**SOLICITATION AMENDMENT  
IFB# 2019026  
CITY OF BUCKEYE  
CONSTRUCTION & CONTRACTING DIVISION  
623.349.6173**

**AMENDMENT #1**

**SOLICITATION: IFB#2019026: PARK SITE LIGHTING**

**IFB# 2019026: PARK SITE LIGHTING  
AMENDMENT NUMBER 1  
AMENDMENT ISSUE DATE: DECEMBER 11, 2019**

**Mesa Small Pole Specification 20161105  
Mesa Detail M83.01**

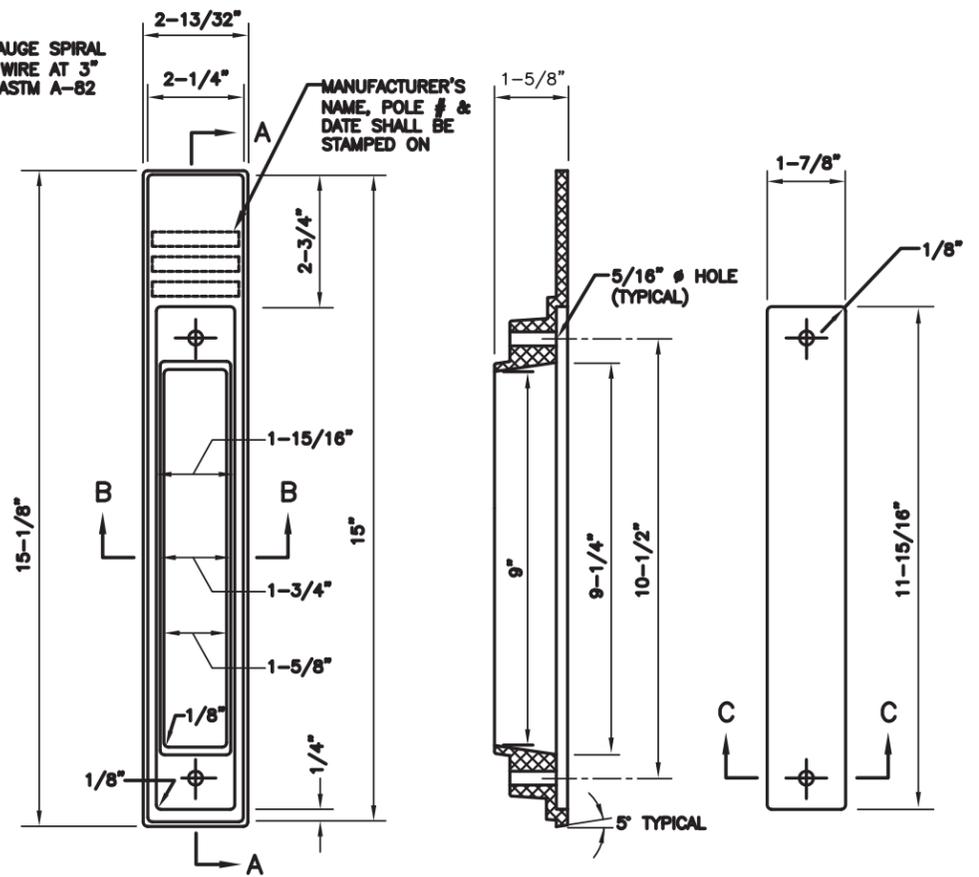
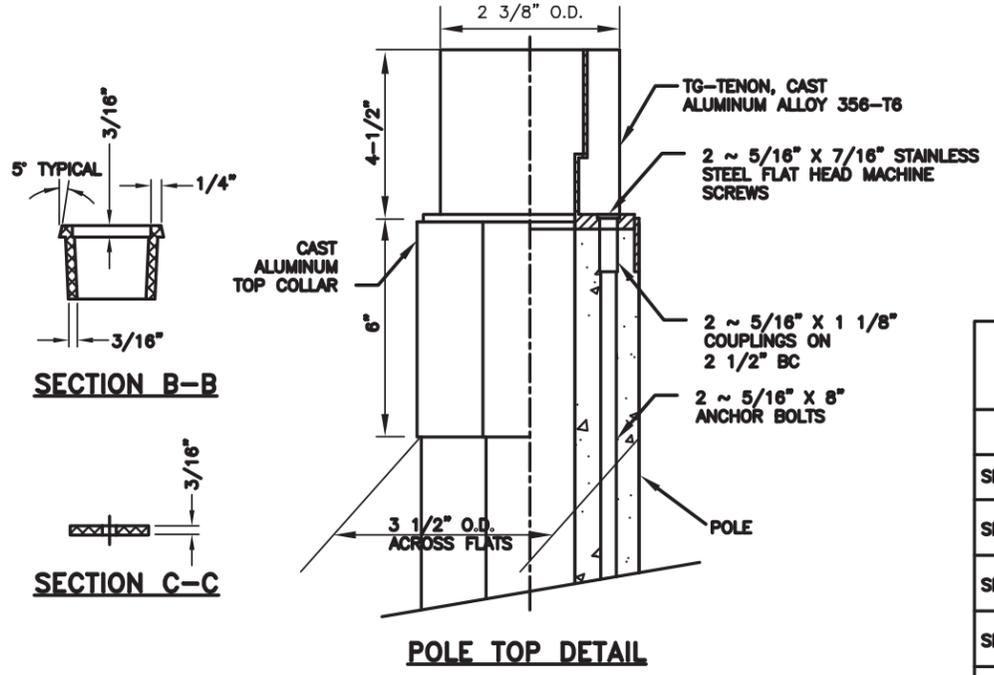
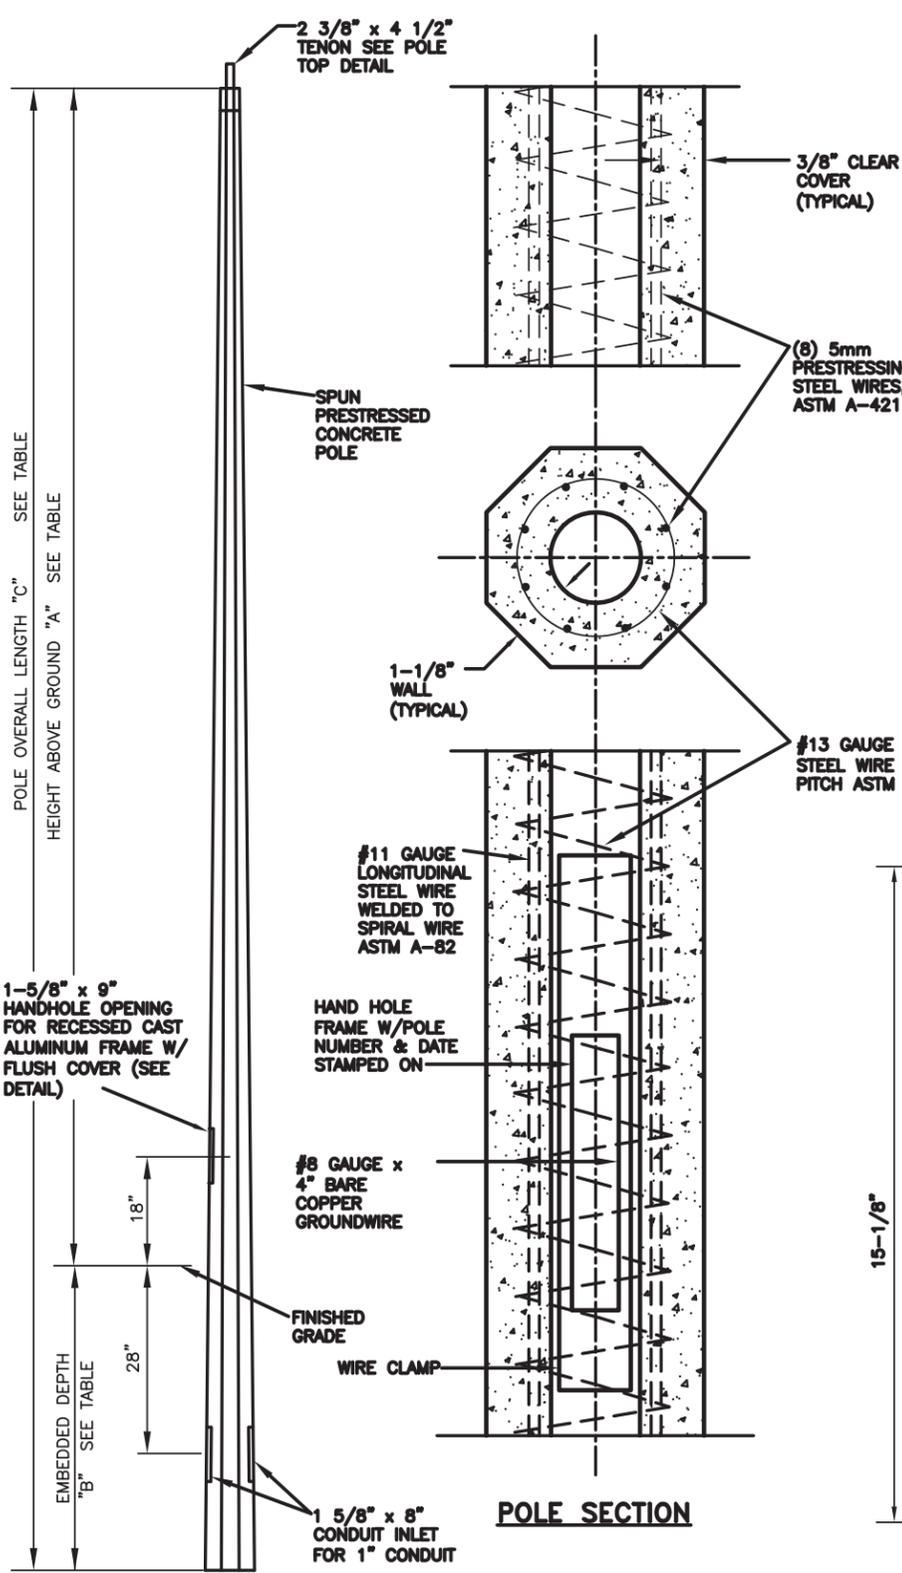
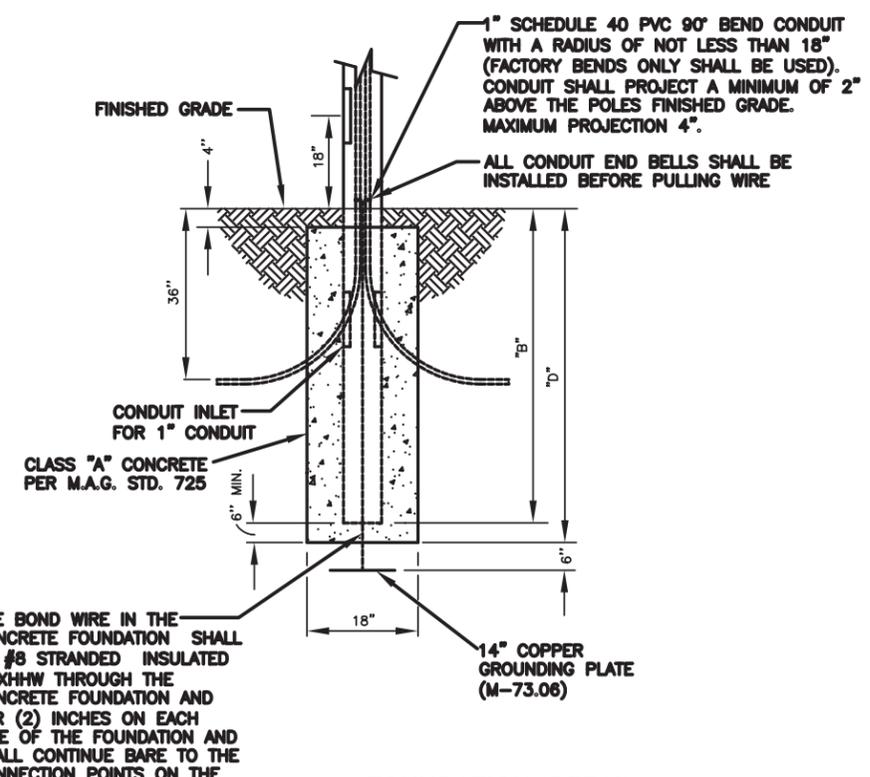
**Q1.** Permitting. What formula do we use to figure the cost of the permit? It has been my experience with the City of Buckeye that they require sealed drawings in order to provide a permit for new installations. Since we are removing the existing poles and bases and installing new poles they may consider this a new installation.

**Pole Base Designs: Include cost of engineering in your bid. To clarify the base detail desired, we are providing the attached base detail from the City of Mesa (Mesa Small Pole Specification) 20161105 Mesa Detail M83.01. See Attachment 1.**
